**BELLEFONTE COMBINED LICENSE APPLICATION – RESPONSE TO REQUEST FOR
ADDITIONAL INFORMATION – EVACUATION TIME ESTIMATE**

Supplement 1 to the Bellefonte ETE Report

Revision 1

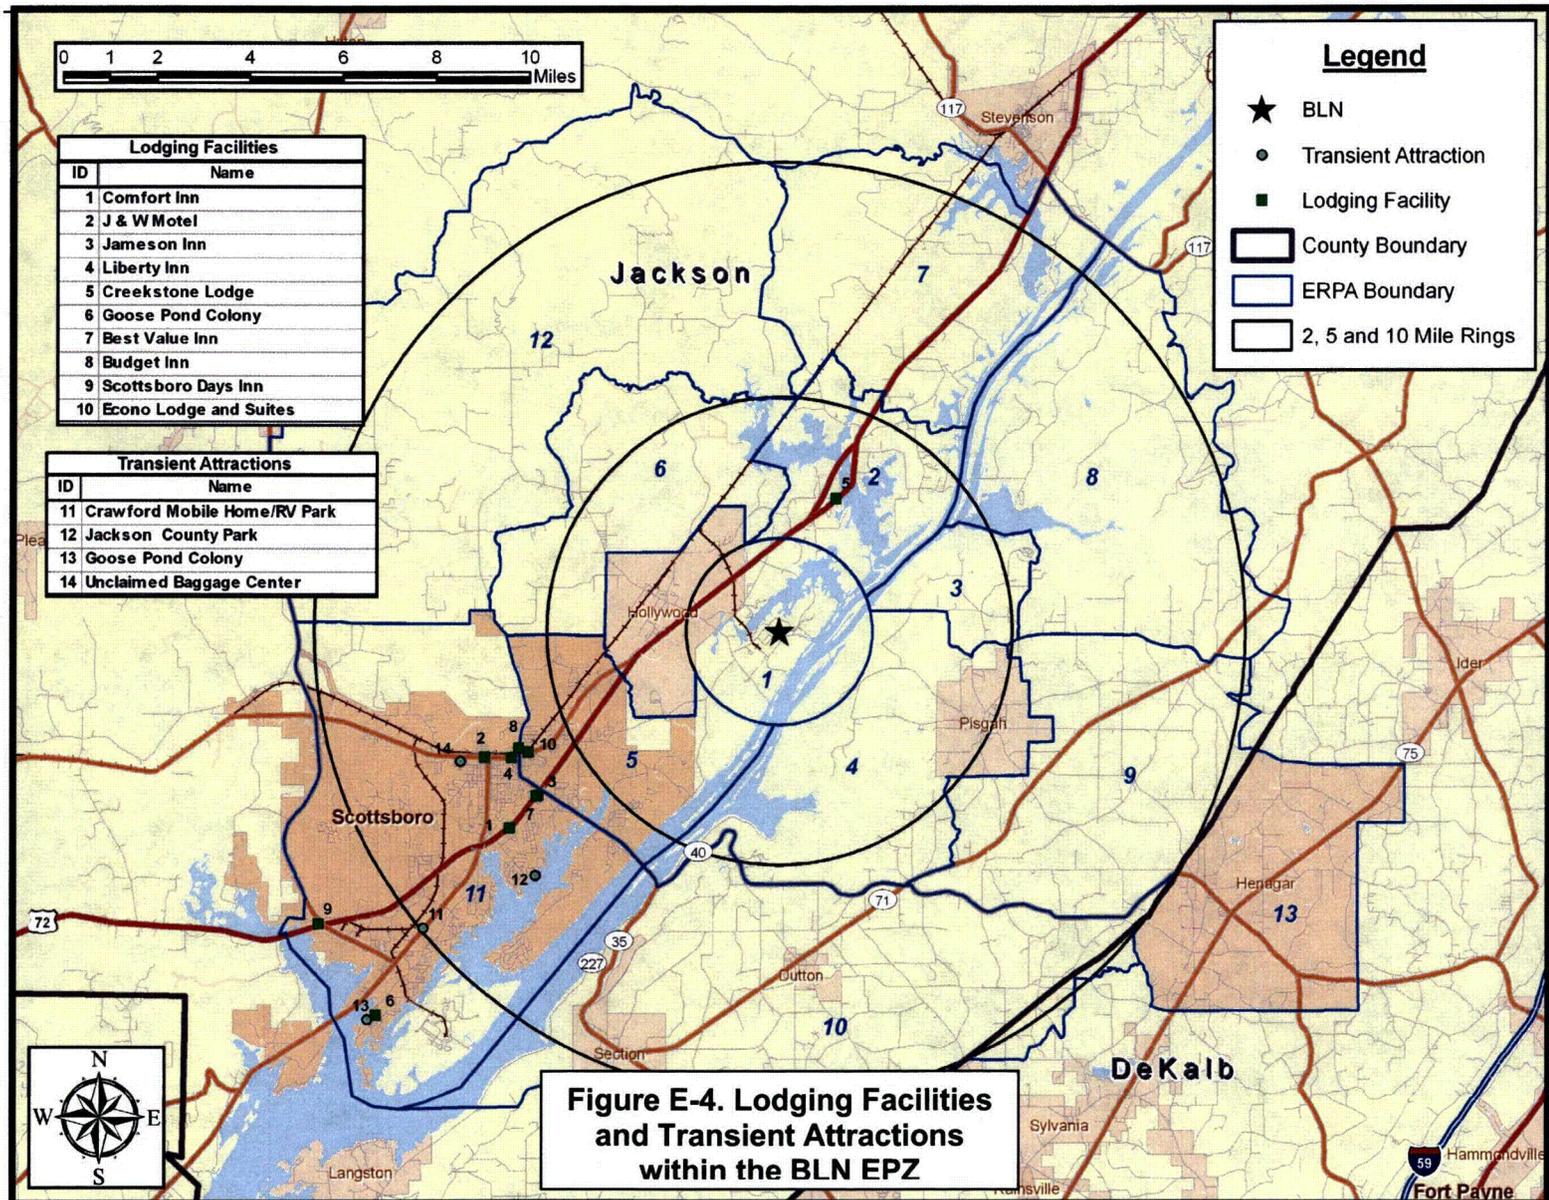
- Supplemented by adding Figure E-4, a GIS map of all lodging facilities and transient attractions within the BLN EPZ. See supplemental figure provided in this Errata Sheet.

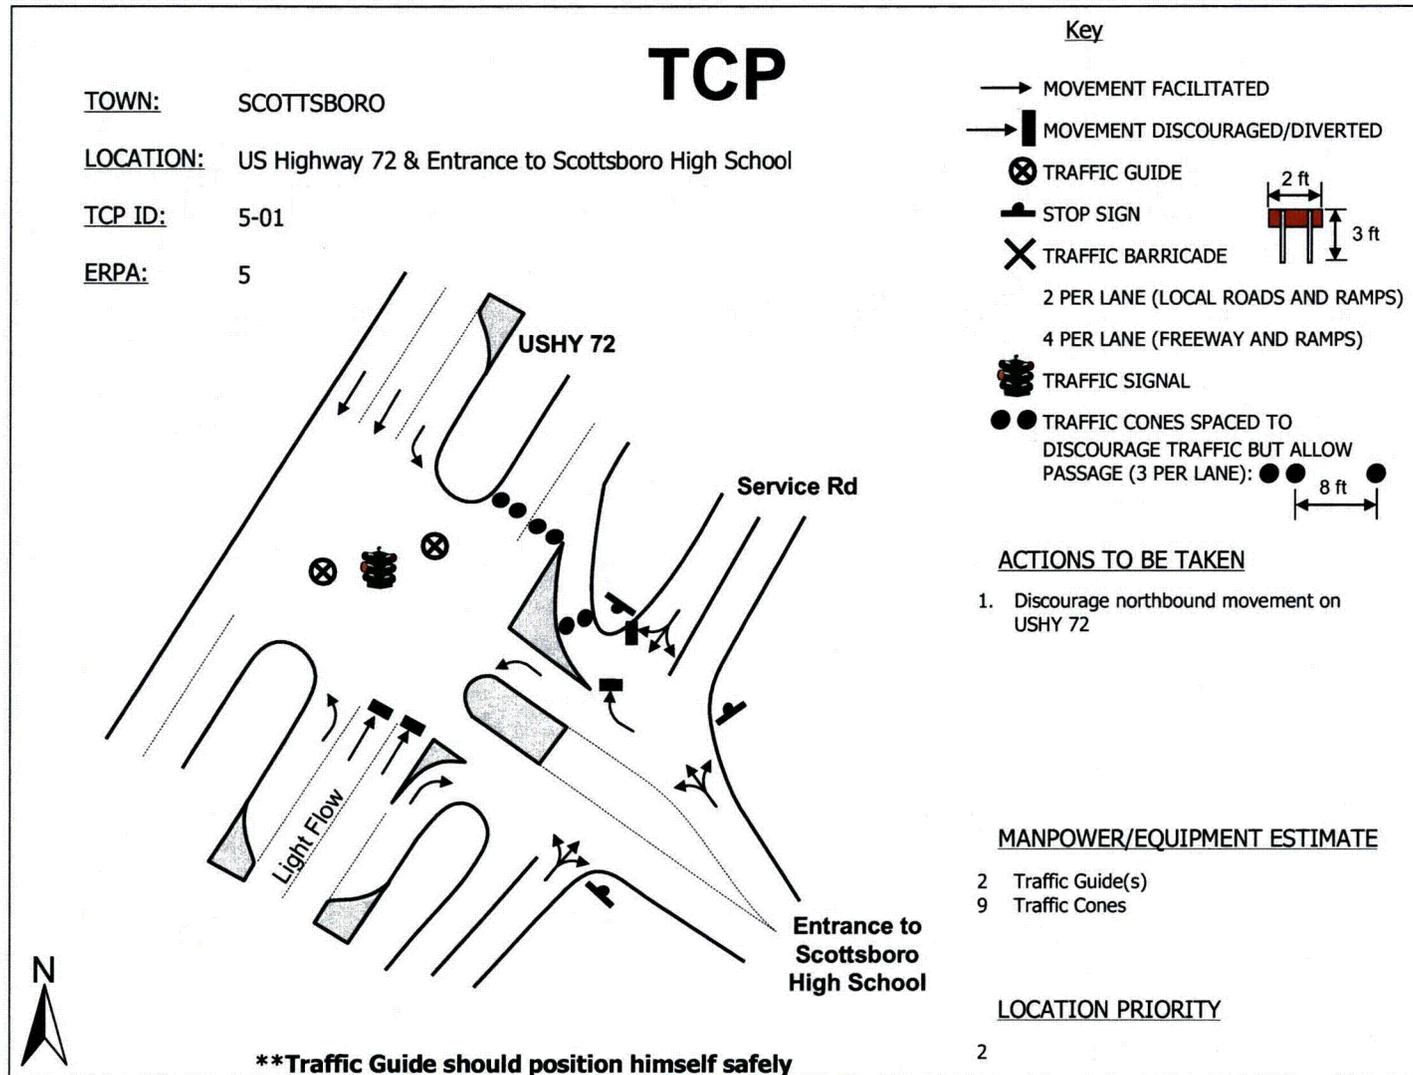
- Replaced barricades on USHY 72 with cones.
- Permitted access to Scottsboro High School.
- Updated the manpower/equipment estimates accordingly.
- See updated figure provided in this Errata Sheet.

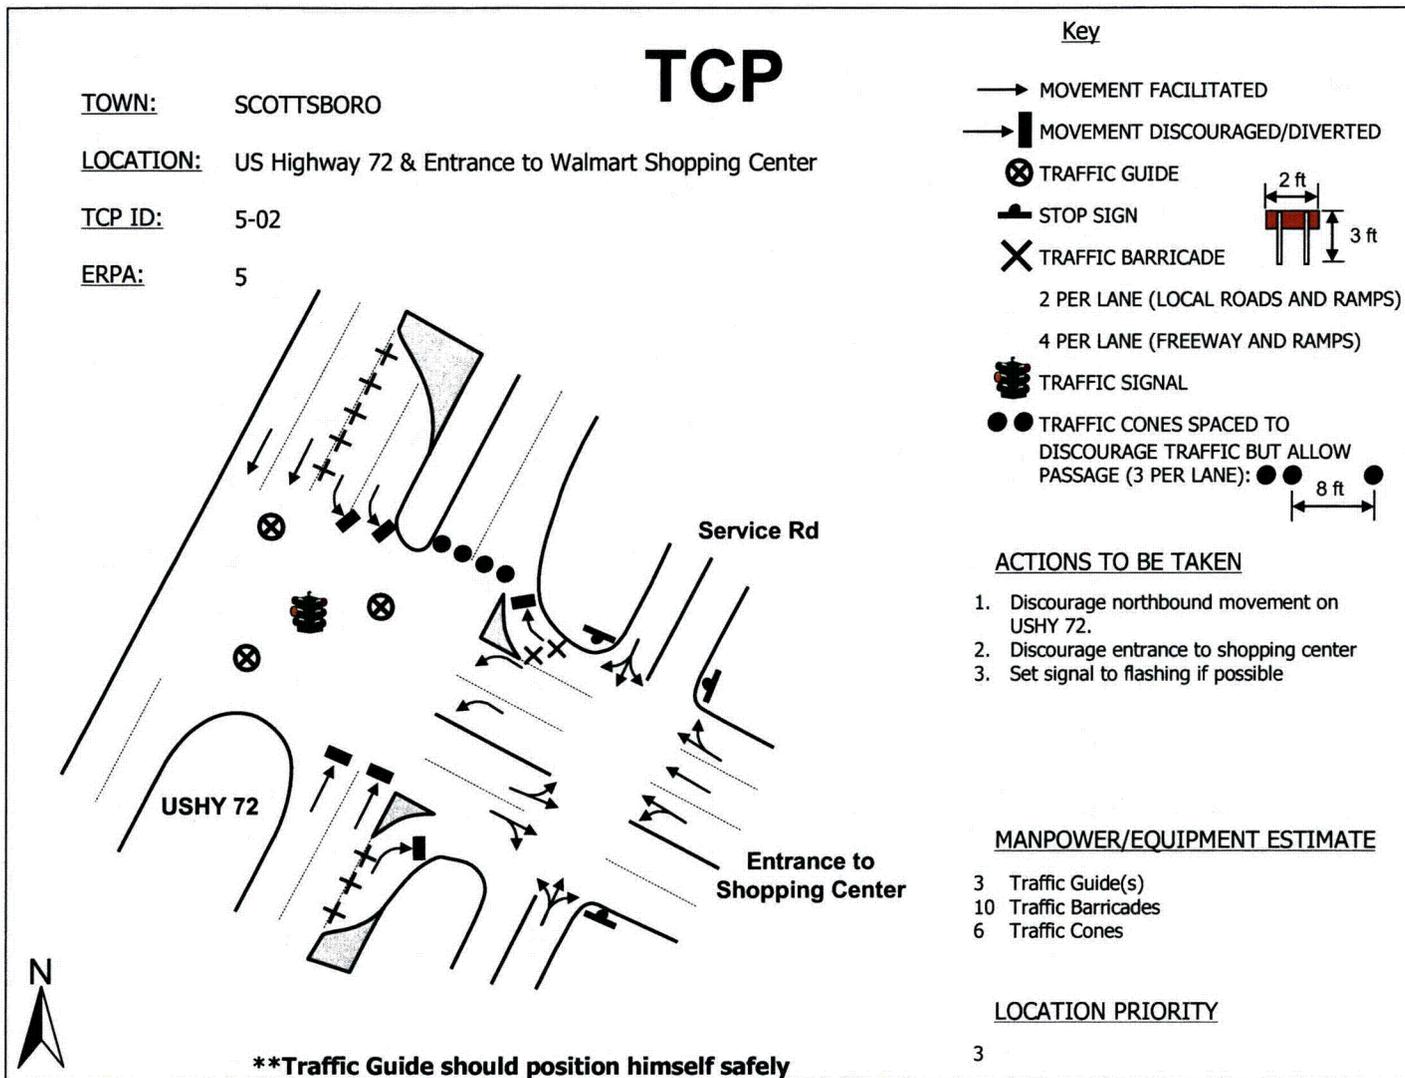
- Replaced barricades on USHY 72 with cones.

- Updated the manpower/equipment estimates accordingly.
- See updated figure provided in this Errata Sheet.

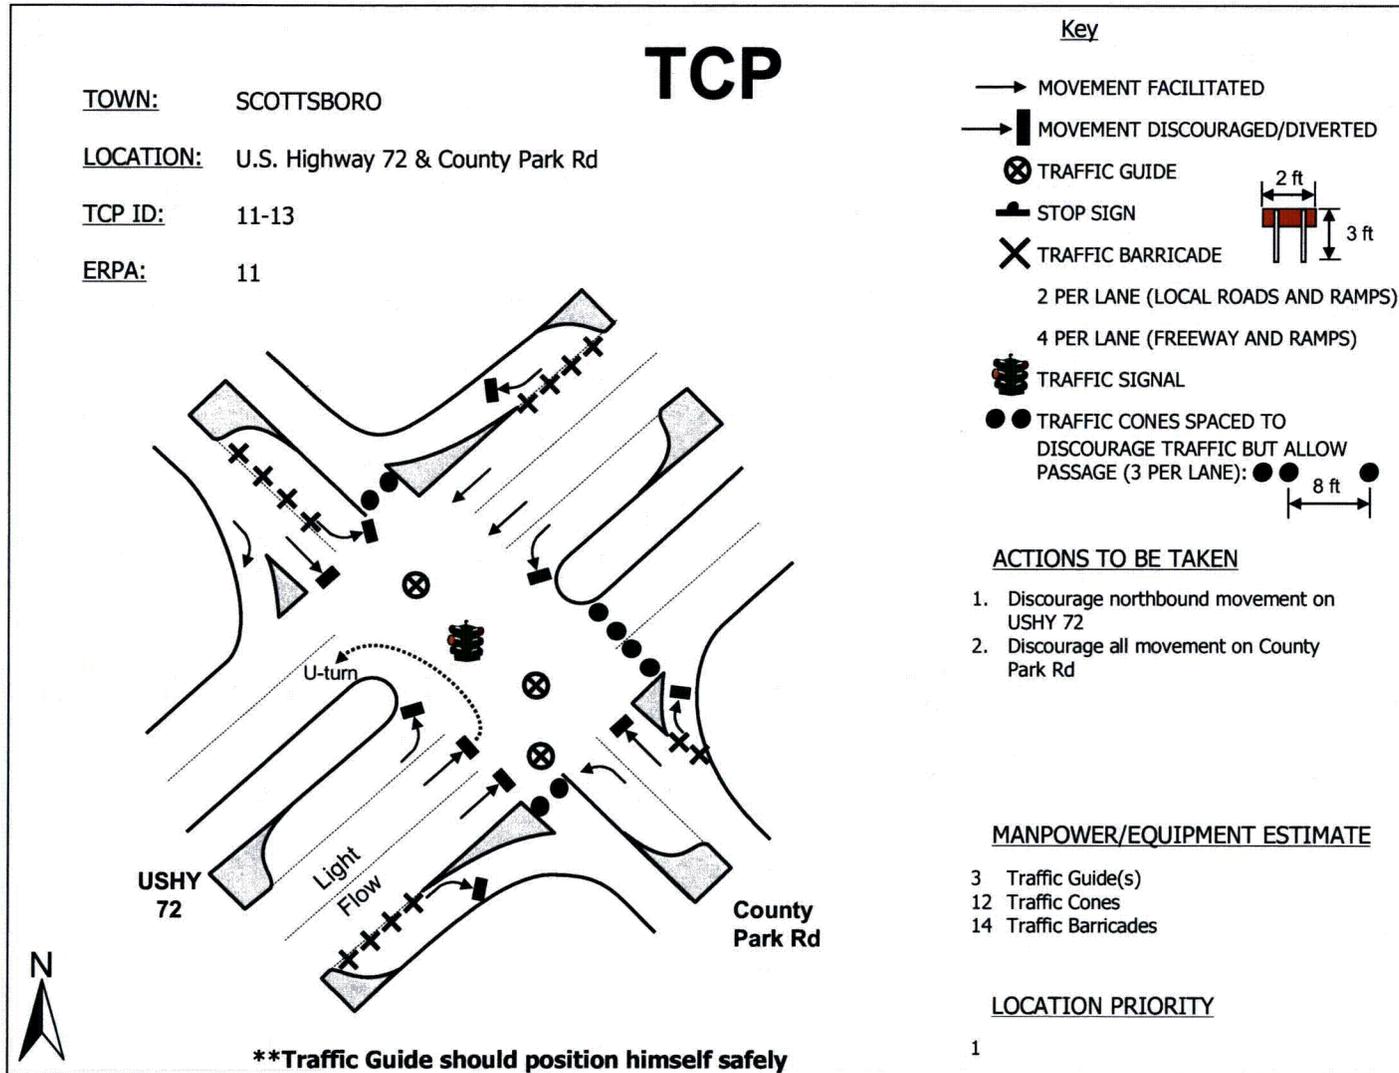
- Replaced barricades on USHY 72 with cones.
- Updated the manpower/equipment estimates accordingly.
- See updated figure provided in this Errata Sheet.
